22 July 2016

**NSW Planning Assessment Commission Determination Report  
Collector Wind Farm (10\_0156 MOD 1)**

Appendix 1  
Topographical Map

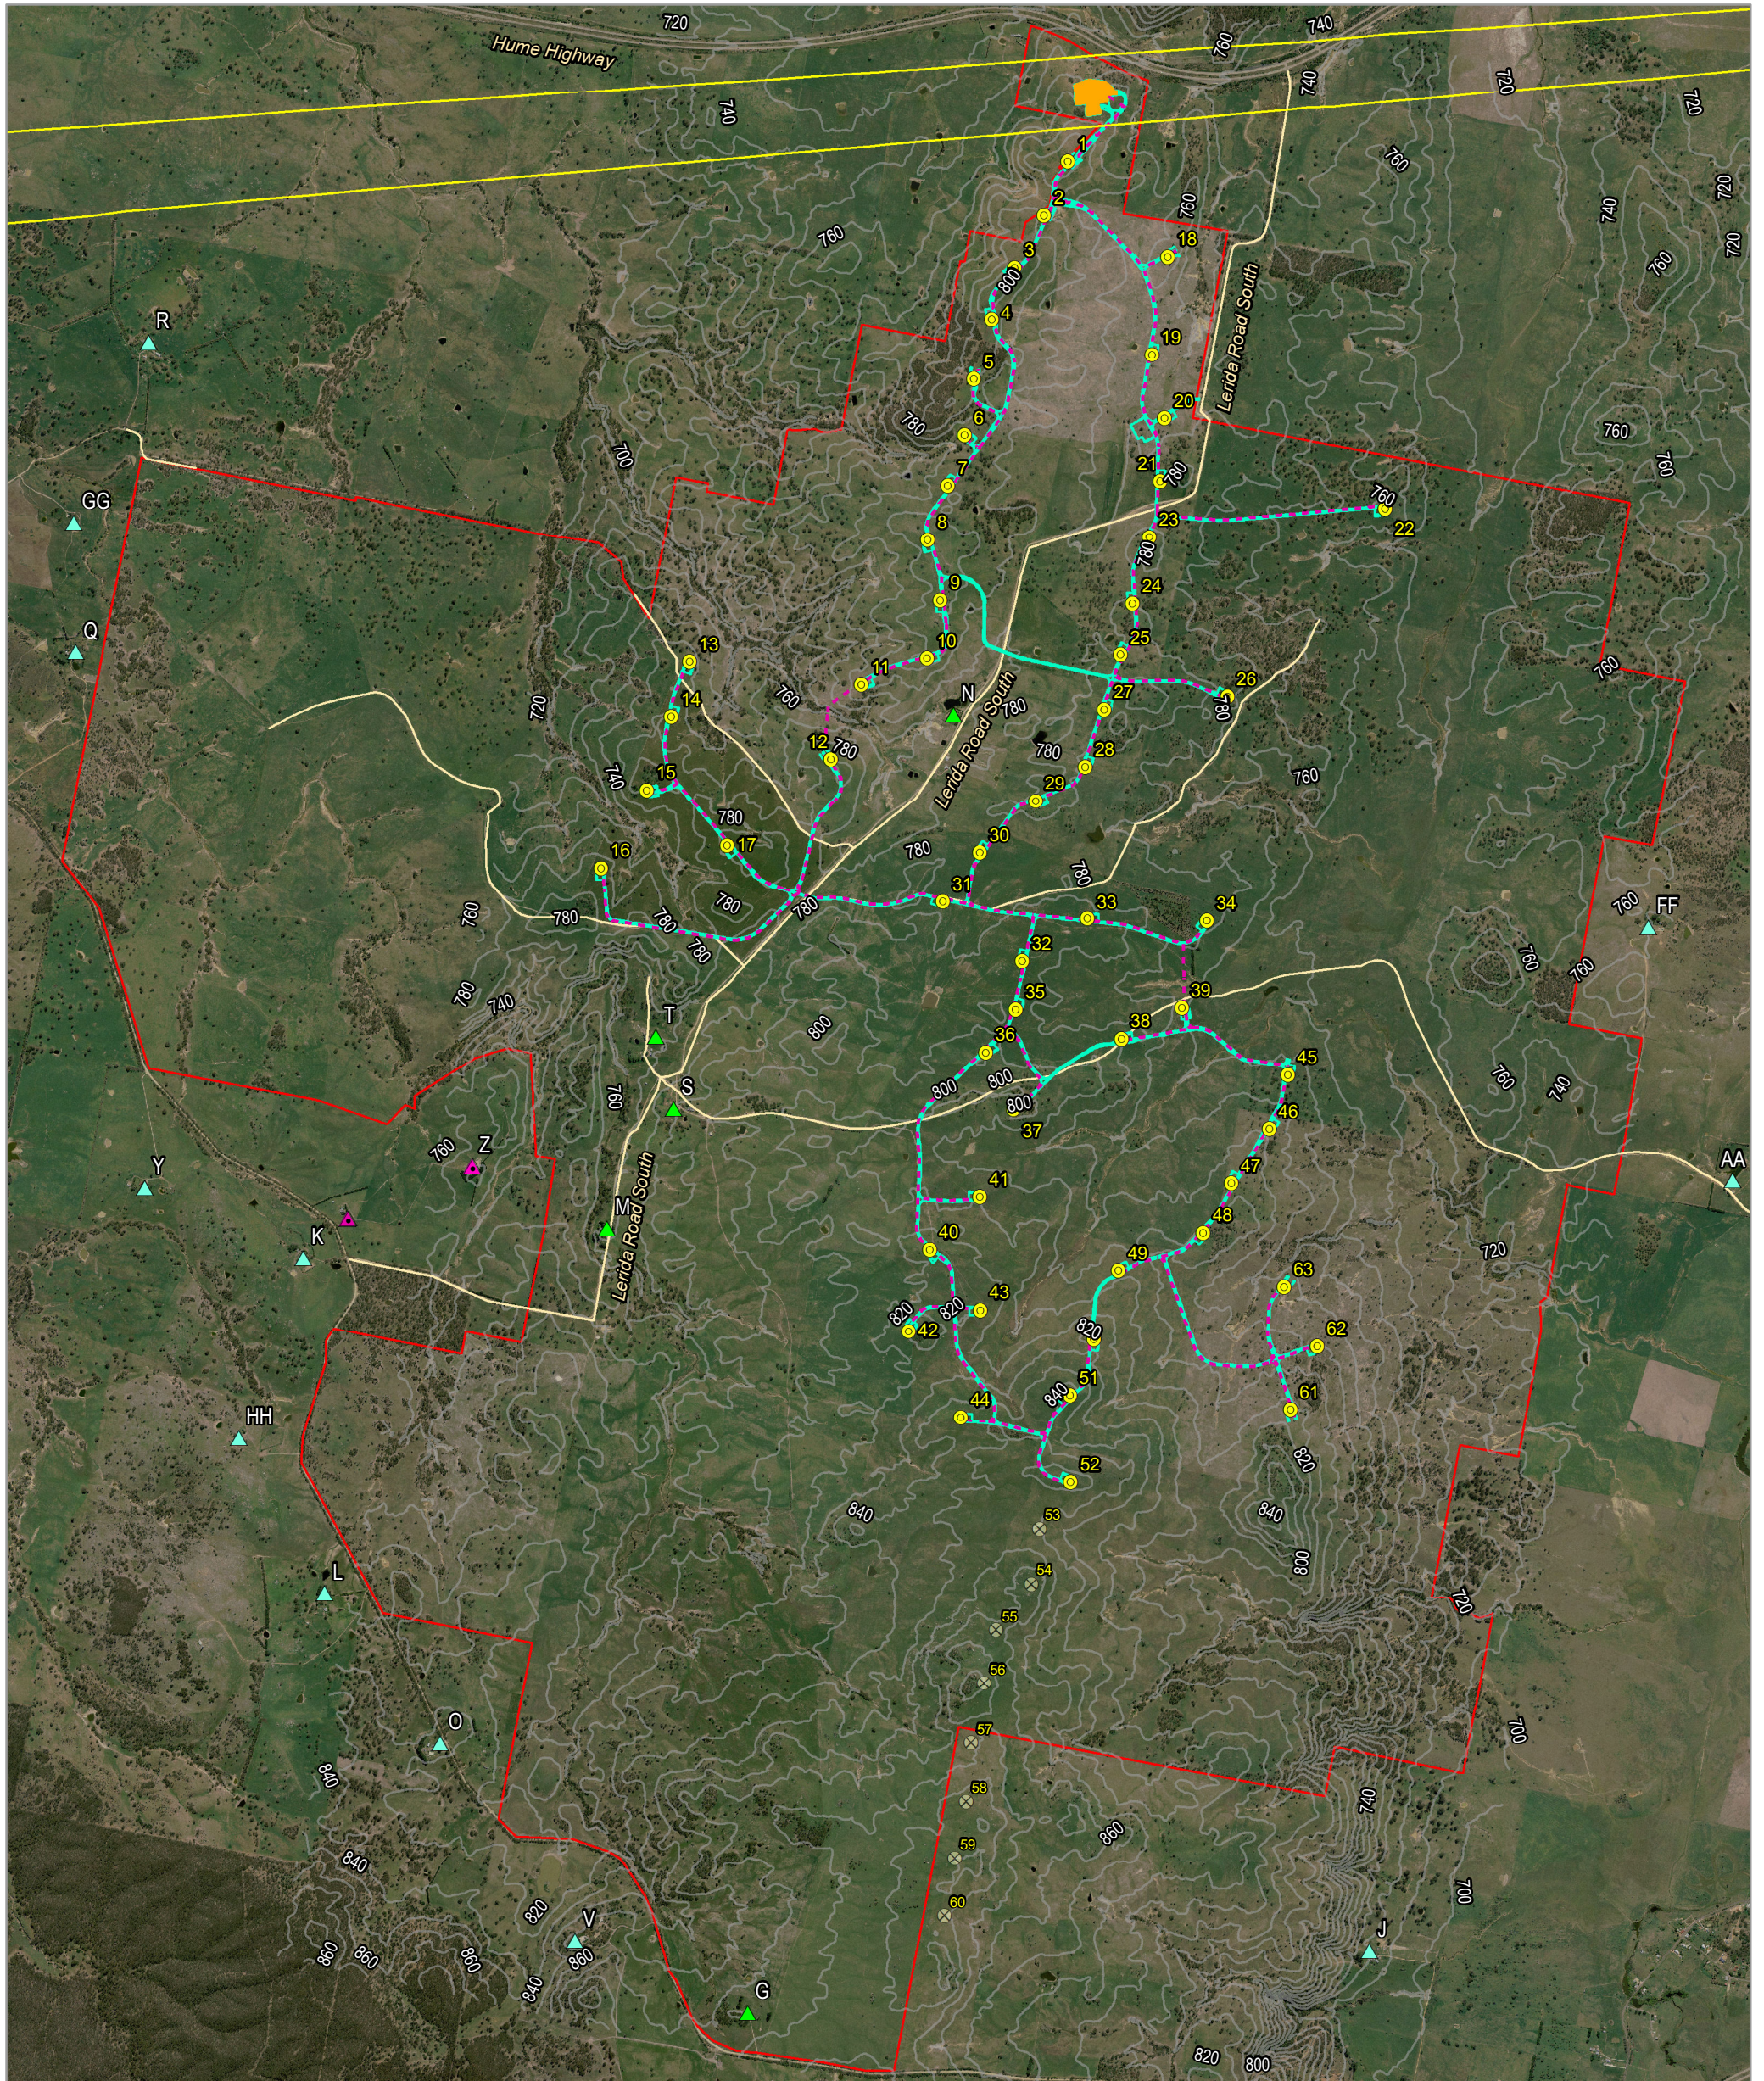
There are no non-associated residences<sup>1</sup> within 2km of the approved wind farm, and there are seven residences between 2km to 3km. A topographical map showing the location of the non-associated residences in relation to the wind turbines is attached at **Appendix 1**.

The Commission has reviewed the Proponent's visual assessment, the Department's recommendation, and has carried out its own inspection of the site and locality. The Commission also sought additional information from the Proponent and the Department to support the visual assessments, including a detailed, topographical map showing the location of the wind turbines in relation to the non-associated dwellings (attached as **Appendix 1**).
